FINAL GENERIC ENVIRONMENTAL IMPACT
STATEMENT
for
CITYGATE

Project Location:
Southeast Quadrant
of East Henrietta Road and Westfall Road
(Formerly the Iola Campus)

August 2010

FIGURE 2

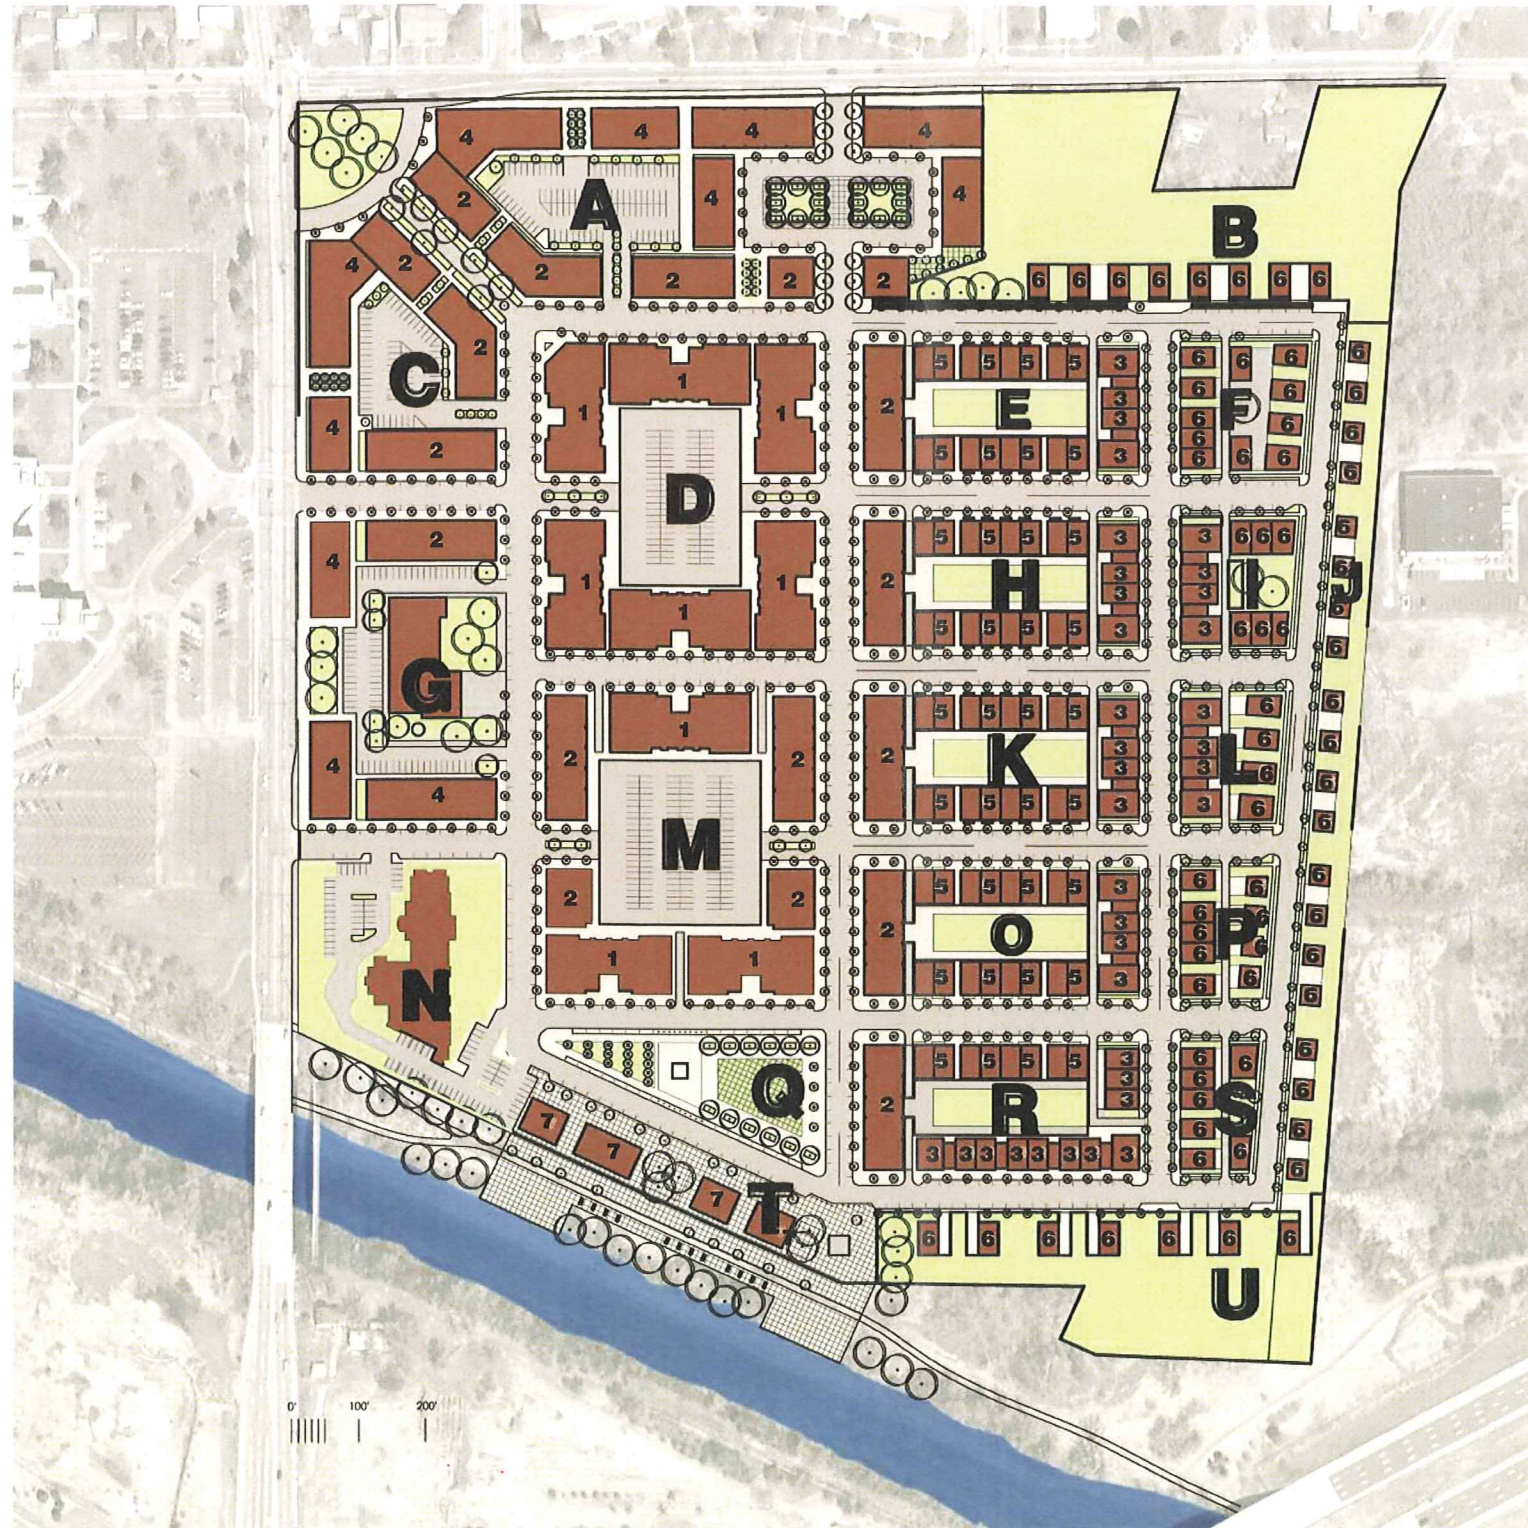
Commenter: Boehner

Response: The RTS center is located off of E. Henrietta Road next to Garage. The revised site plan identifies the route that will be utilized by buses entering from and exiting onto E. Henrietta Road. See Figure 2 Street Network. The proposed transit center is reflected in the revisions to the traffic study. See Appendix H.

FIGURE 3

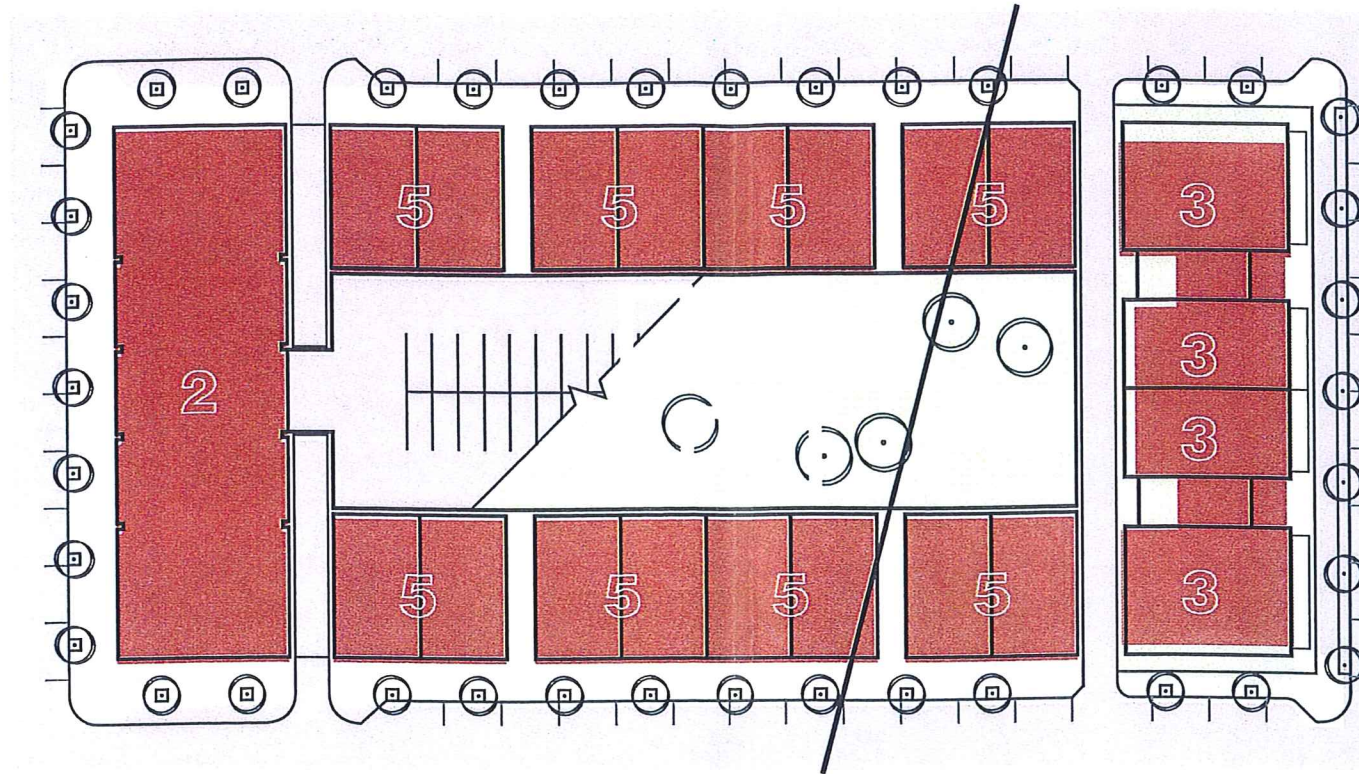
12. In the calculations for parking spaces, how many parking spaces are planned for each use? What will the total number of parking spaces be for Citygate?

Response: Approximately 2,700 parking spaces are proposed in the revised concept plan. A matrix in Figure 3, based on the revised concept plan, better defines the number of parking spots for each use.
